Case No: A.15-02-023

PREPARED TESTIMONY OF SAM BLAKESLEE

**BEFORE THE PUBLIC UTILITIES COMMISSION
OF THE STATE OF CALIFORNIA
JULY 14, 2015**

TESTIMONY OF DR. SAM BLAKESLEE
Application 15-02-023

FIGURE A

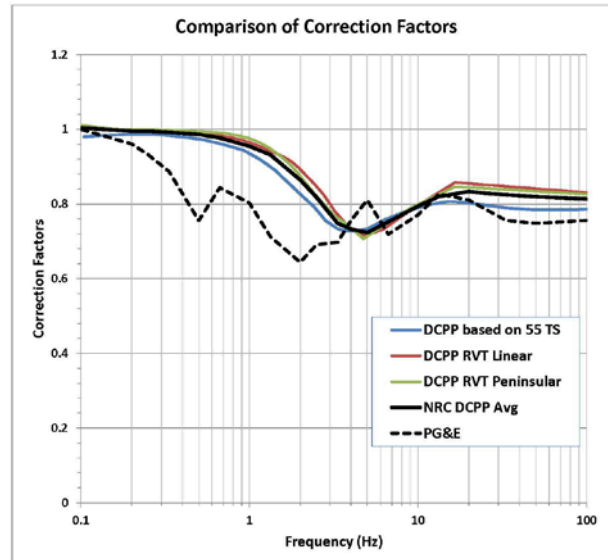
As a simple example of the value of such an approach, NRC staff provided a graphic [see FIGURE A, page 29] of a site effect transfer function for Diablo using a number of different assumptions¹⁰. As can be seen in the adjacent figure, in each of the cases the NRC results were more conservative than PG&E's. The de-amplification effect at 2 Hz averaged about 10% using the three NRC's methods whereas the PG&E approach tripled the de-amplification effect. This graphic helps show the significance of choosing one method or parametric value over another. The CCCSIP should present information in a similar manner so that it is more accessible to the average technical reader.

FIGURE B:

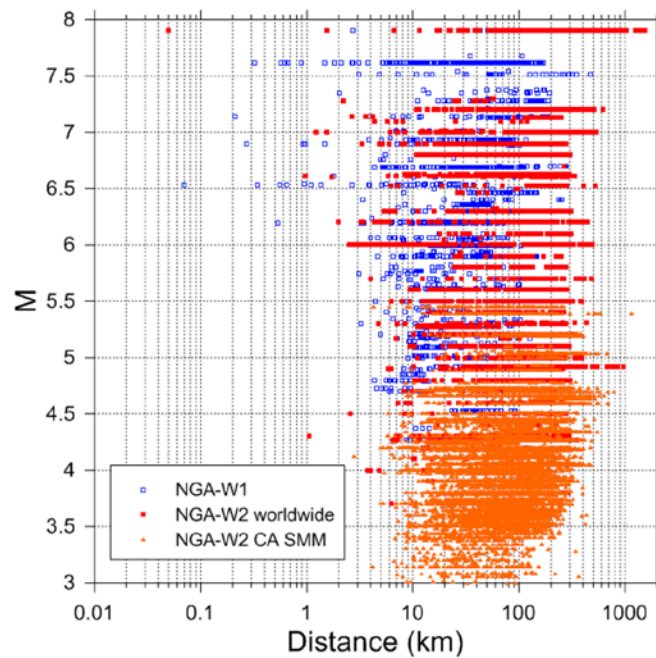
The fundamental problem is that only a tiny amount of the data used to create these new methodologies, perhaps less than 1%, include recordings of large earthquakes (>M7), in the extreme near field (<2km), on hard rock sites (>1km/s) – which is the exactly the circumstance at Diablo (see figure 1.2 and note the small number of data points of large earthquakes recorded in the “box” delineated between the distances 0-2 km and between M7-8). [see FIGURE B, Page 29].

Figure 10. Comparison of Individual 84th Percentile Ground Motion Prediction Equations with Best Estimate Parameters and Diablo Canyon Review Spectrum

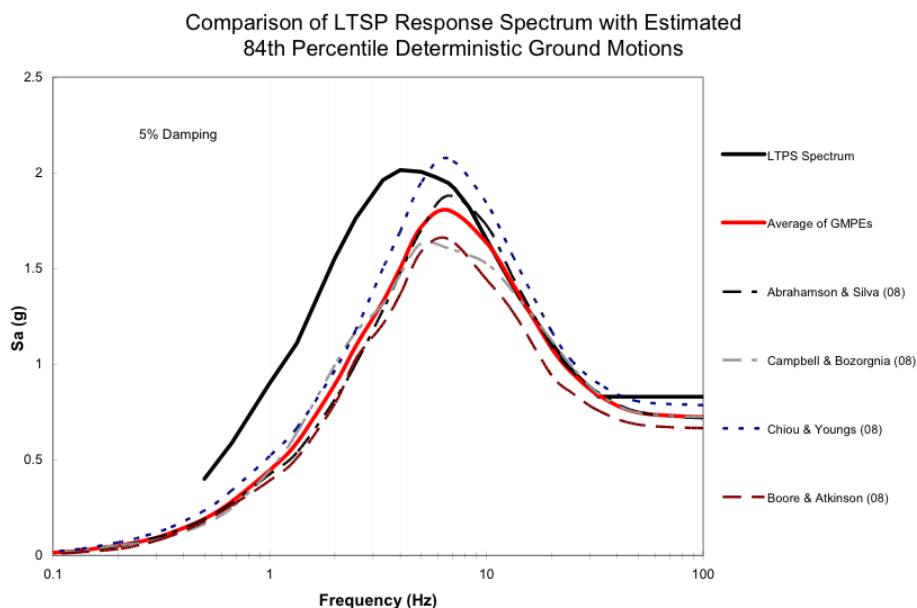
The five NGA GMPEs which, when averaged, produce GMPE-3 are each shown in figure 10 from the NRC report. The NRC staff analysis also tested the significance of using the lower-bound estimate of rock velocity rather than the “best estimate” (lower velocity corresponds to higher shaking). Using a rock velocity of 800 m/s instead of 1,100 m/s resulted in a spectrum that, “exceeds the LTSP spectrum by a small amount over some frequencies.” In summary, by using reasonable but somewhat more conservative approaches to the three available variables (the NGA model selection, earthquake magnitude estimate, or rock

velocity) the spectrum was found to be “very close” or “exceeds...by a small amount.” This result was quite significant because it showed that, even in the early days when the Shoreline Fault was still believed to be relatively small, shaking could exceed the LTSP Spectrum assuming certain models and certain rock parameters. The Chiou & Youngs (08) GMPE (dotted blue line) exceeds the LTSP Spectrum (solid black line) at about 7 Hz and above, the others are just a little below, hence the characterization that they are “*very close*” (emphasis added).

Figure 3: Shakal et. al., 2004 showing remarkably high and low accelerations in the extreme near-field (rupture started where the star is shown and then propagated to the north-east and south-west where they stopped)

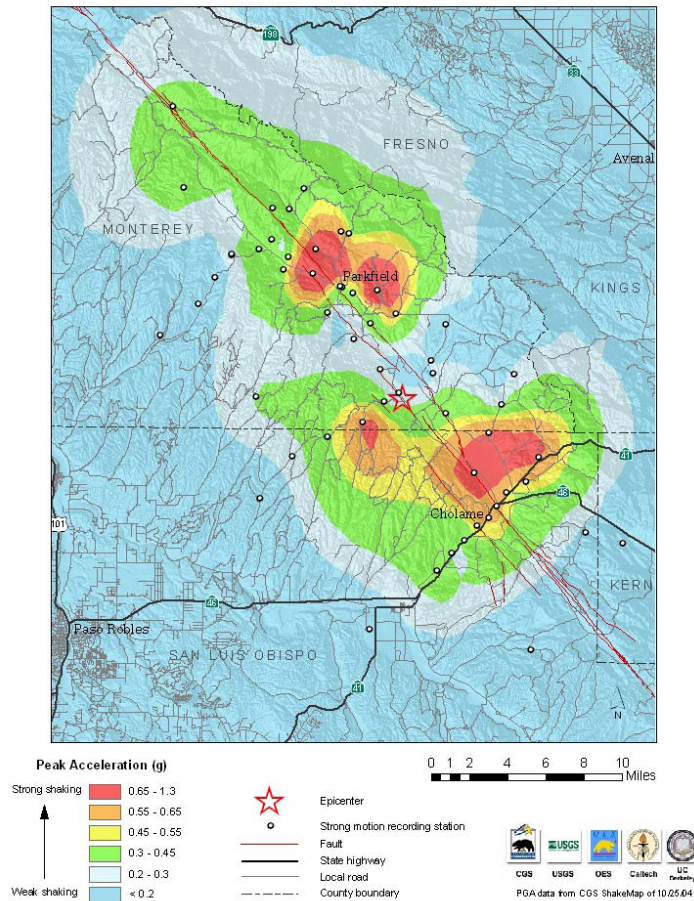
For example, in 2004, 48 strong-motion recordings within 10 km of the San Andreas Fault were made of the M6.0 Parkfield earthquake^{xii}. This dataset was used to test three different attenuation-distance equations. These equations are shown to do a good job of making accurate predictions for distances beyond about 10 km, but the observed shaking becomes highly variable in close proximity to the fault. Rather than finding accurate predictions of mean shaking in the extreme near-field the paper notes,

“Peak ground acceleration in the near-fault region ranges from 0.13 g at Fault Zone 4, to 1.31 g at Fault Zone 14, ten times larger, to over 2.5 g at Fault Zone 16 (where the motion exceeded the instrument capacity and the actual maximum value is still being estimated).”

The dense strong-motion Parkfield recordings are relevant to the conclusions of the Report for a number of reasons.

(Figure 7a from IPRP Report)

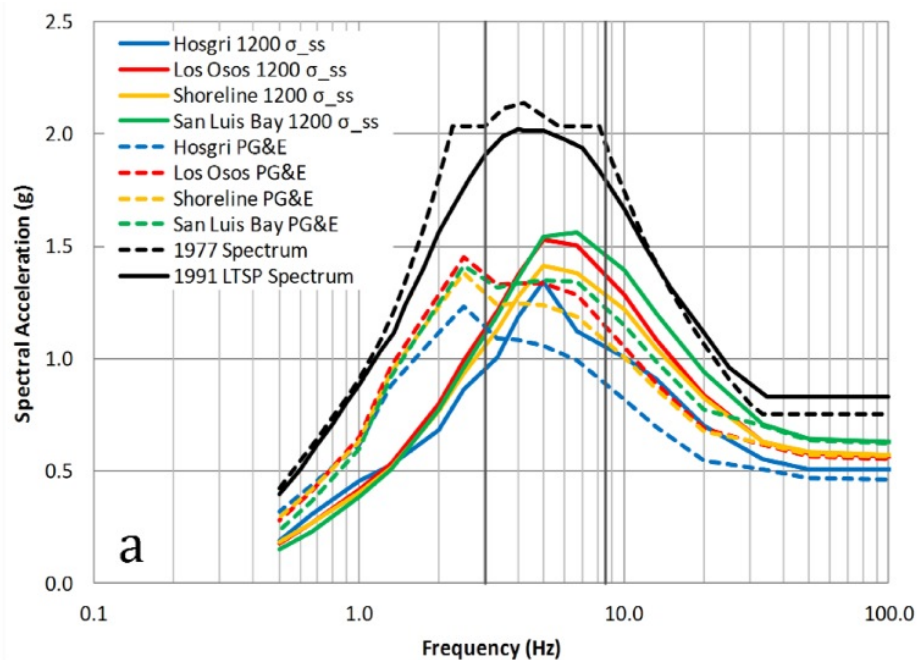
As seen in Figure 7a from the Independent Peer Review Panel (IPRP) report and in a number of other related reports, the new less-conservative equations cause a major reduction in shaking across the entirety of the frequency spectrum from a hypothetical earthquake on the Hosgri fault (compare blue lines which use the newly devised methods with black lines which use the prior methods, in figure 7a above). In the frequency range from 2-10 Hz the less-conservative methodologies have cut the maximum estimated acceleration from 2 g down to about 1.3 g. At the peak-frequency range, from 30-100 hz, the maximum estimated acceleration as been reduced by a third from .75 g to under .50 g. In fact the de-amplification effect is even larger than this comparison suggests because the blue lines, which represent the shaking on the re-interpreted Hosgri, assume a larger rupture on the Hosgri Fault than the earthquake that was used to initially create the 1977 HE basis exception.

More importantly, as can be seen in Figure 7a the shaking from the Los Osos, Shoreline, San Luis Bay Faults all exceed the re-interpreted Hosgri (red, yellow, green lines are all above the blue line). **One can reasonably conclude that, if the original analytical methods had been used to estimate ground motion, the new seismic threats would exceed the original HE and LTSP spectra.**

(Figure 7c. from IPRP Report)

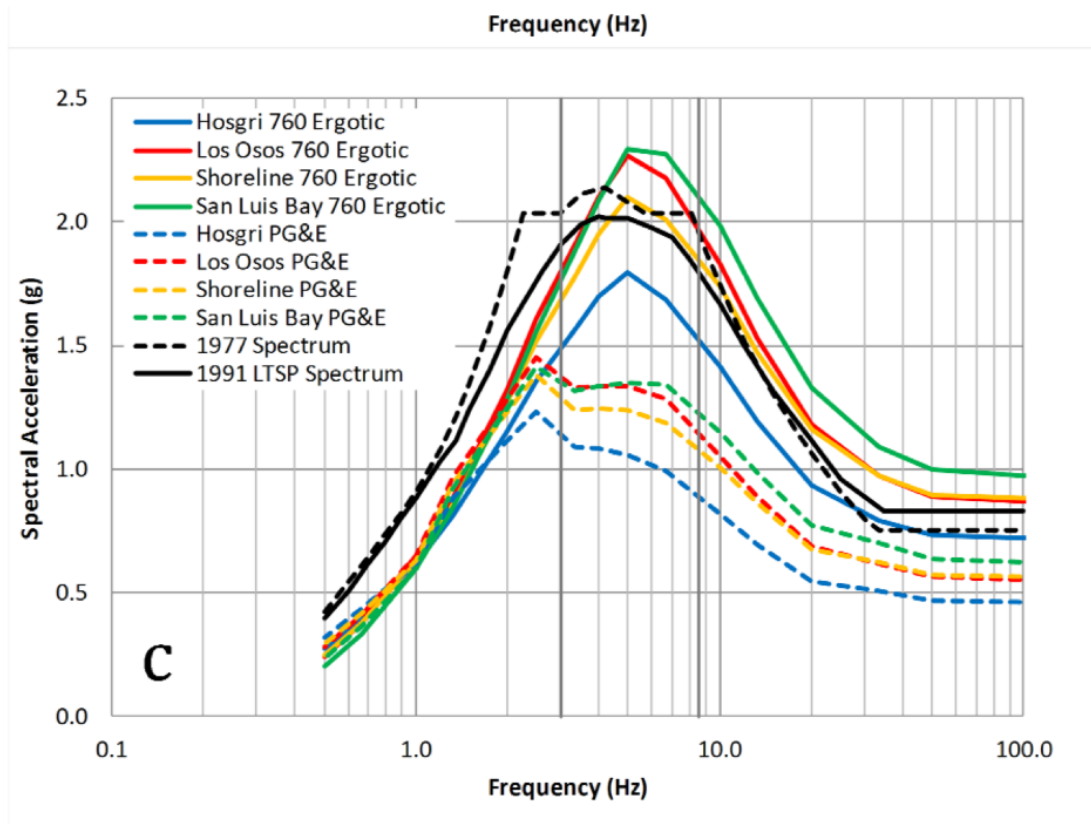
“These two figures also show that if DCPD site had a Vs30 value of 760 m/s rather than 1,200 m/s, and if the site behaves more like an average site in ground motion amplification, **some deterministic spectra would exceed the 1991 LTSP spectrum^{xiii}**” (figure 7c below).

In fact, it is more than just “some.” Under the scenario shown in Figure 7c the IPRP shows that the LTSP/HE spectrum is exceeded by **all** of the newly discovered and re-interpreted seismic threats, including earthquakes on the Shoreline Fault, the Los Osos Fault, and the San Luis Bay Fault (note that the red, yellow, and green lines are all above the solid black line). The fourth and largest hypothetical earthquake scenario, a M7.3 rupture on a joint Hosgri/Shoreline Fault, is not shown on this figure but could reasonably be assumed to exceed the LTSP/HE as well.

This sensitivity analysis shows that the cumulative effect of less-conservative fast rock velocities along with less-conservative GMPEs is clearly not a small issue, nor is it a only an academic issue. The IPRP reviewed the limited wellbore data (see IPRP Report 6 Figure 4) and concluded that the wellbore velocities appeared to be lower than those estimated by PG&E, which could result in the conclusion that PG&E has underestimated shaking from new seismic threats even if the new equations are allowed. The IPRP challenged PG&E's use of wellbore data at the ISFSI site to justify the higher 1,200 m/s velocity and instead focused on the velocities measured in the wellbore data closest to the facility.

Figure 4. Shear wave velocity profiles from 1978 downhole velocity surveys (provided by PG&E).

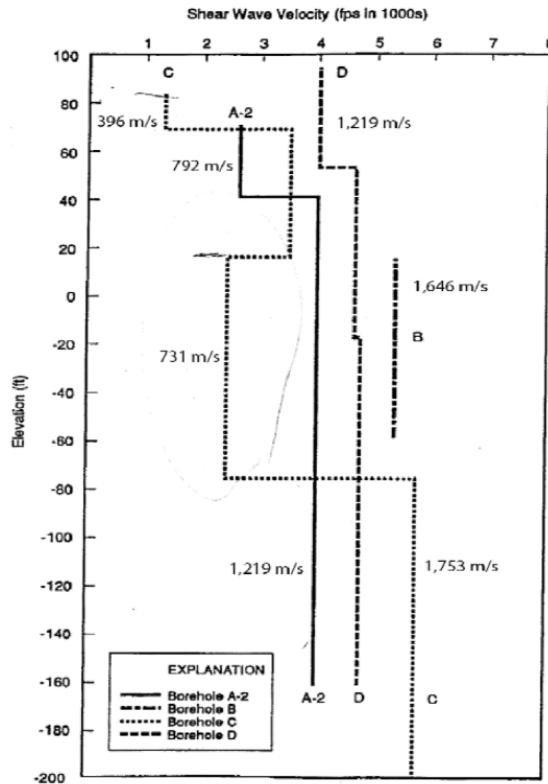
"Consider the three usable measured profiles, A-2, C, and D, the mean value at 10 m is approximately 800m/s, considerably below PG&E's mean of 1200m/s." and "If A-2 had the same velocity as C at a depth of 5m, consistent with the relative weathering described in the borehole logs, the mean velocity at that depth would be about 650m/s, also below PG&E's mean value of 1000m/s."

Recommendation: To provide resolution to the uncertainties noted by the IPRP, it would be worthwhile to require PG&E to follow through on their earlier draft reply intentions and drill a number of relatively shallow wells around the site so that rock velocity data can be acquired with a high degree of confidence. Such wells are not very expensive, are easily logged, and can resolve one of the most critical sources of uncertainty in this analysis. It is very common to instrument such wells so that measurements of surface and downhole wavefields can be acquired, thereby allowing highly accurate, empirically-derived near-surface transfer functions to be calculated (Blakeslee & Malin 1991)³⁰. As PG&E's earlier response indicates, PG&E was going to place this task in their "LTSP" or Long Term Seismic Program. The
